1529 COMOX STREET (COMPLETE APPLICATION)
DE418115 - ZONE RM-5

DEVELOPMENT PERMIT STAFF COMMITTEE MEMBERS

- **Proposal:** To add to and relocate the existing multiple dwelling building (8 units + 4 sleeping units) towards the front property line and, to develop the rear of the site with a new 4 storey multiple dwelling infill building consisting of 17 rental units addressed from Henshaw Lane.

DEVELOPMENT PERMIT STAFF COMMITTEE RECOMMENDATION: APPROVE

DWG. NO. **A104**
Scale: 3/16" = 1'-0"

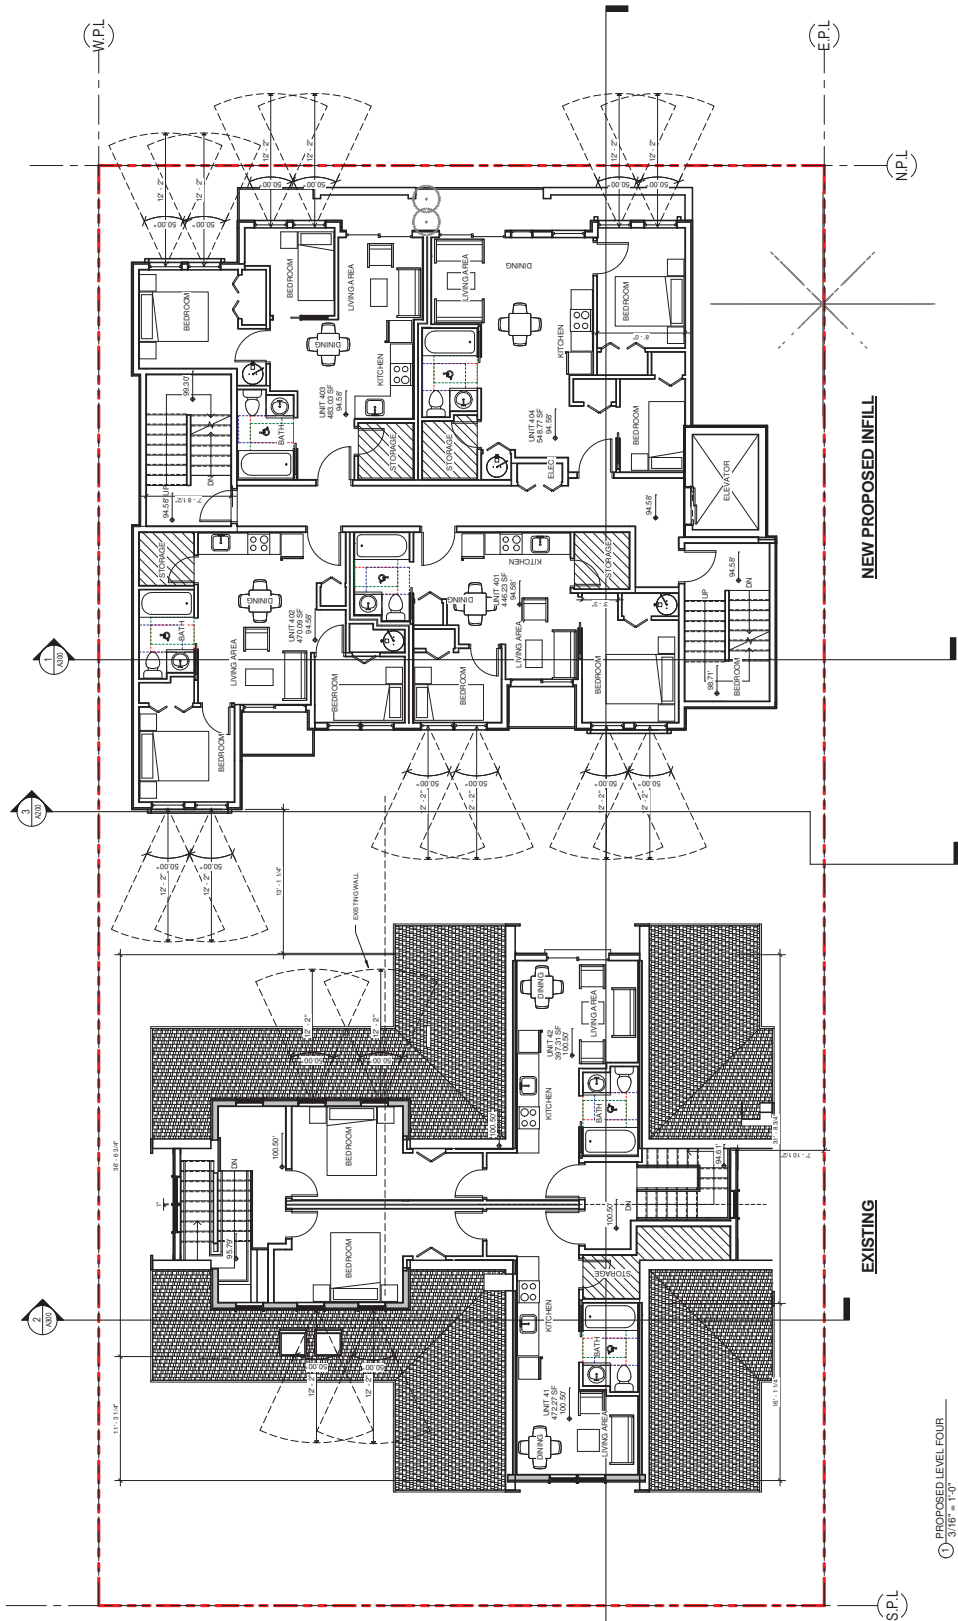
Note to Applicant: Floor plans on page A103 show a wall that may be enclosing the balcony.

① PROPOSED ROOF LEVEL
 3/16" = 1'-0"

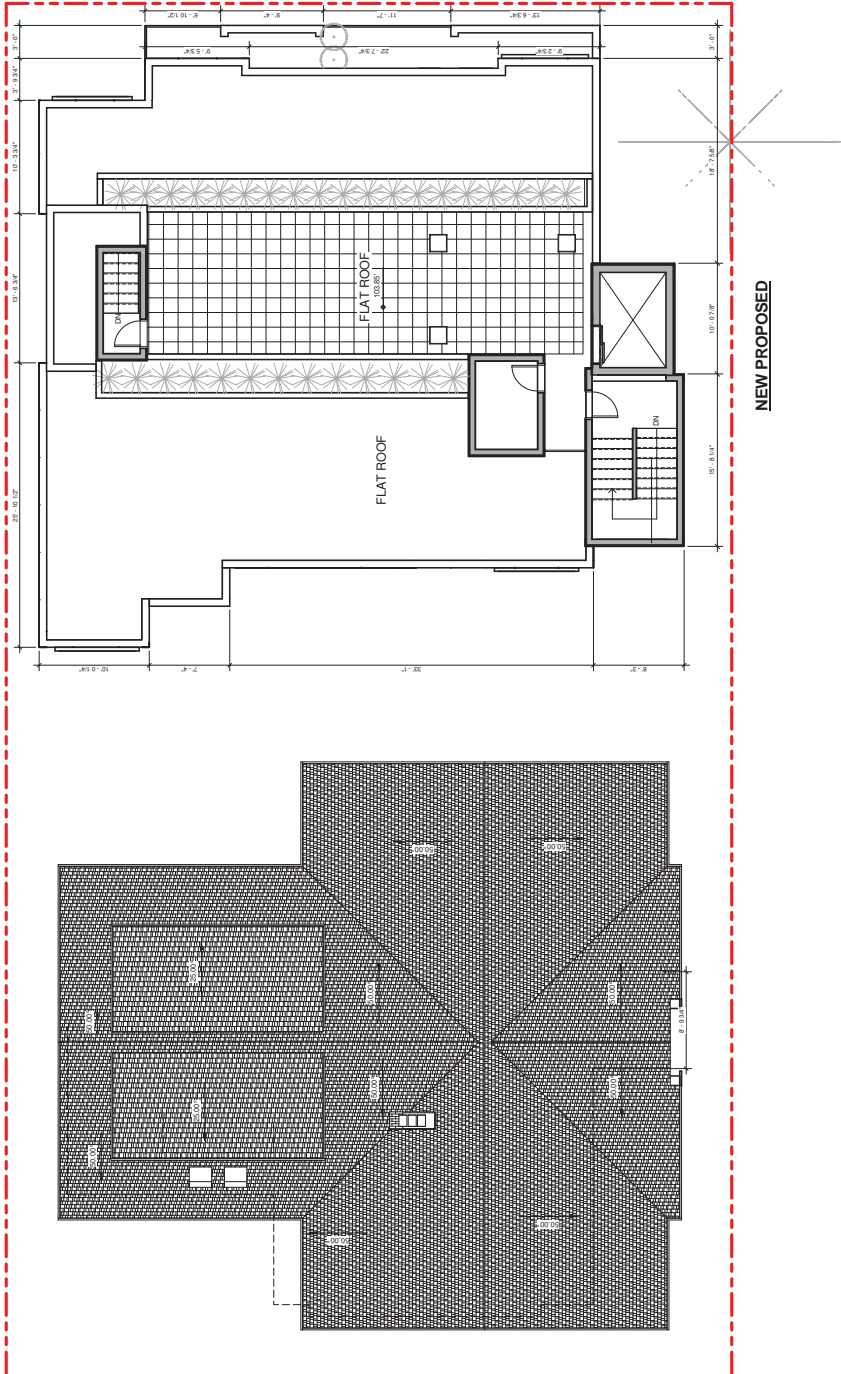
i. eliminate rooftop storage area and clarify that the design of the rooftop amenity area is in line with applicable policies, bylaws, and guidelines;
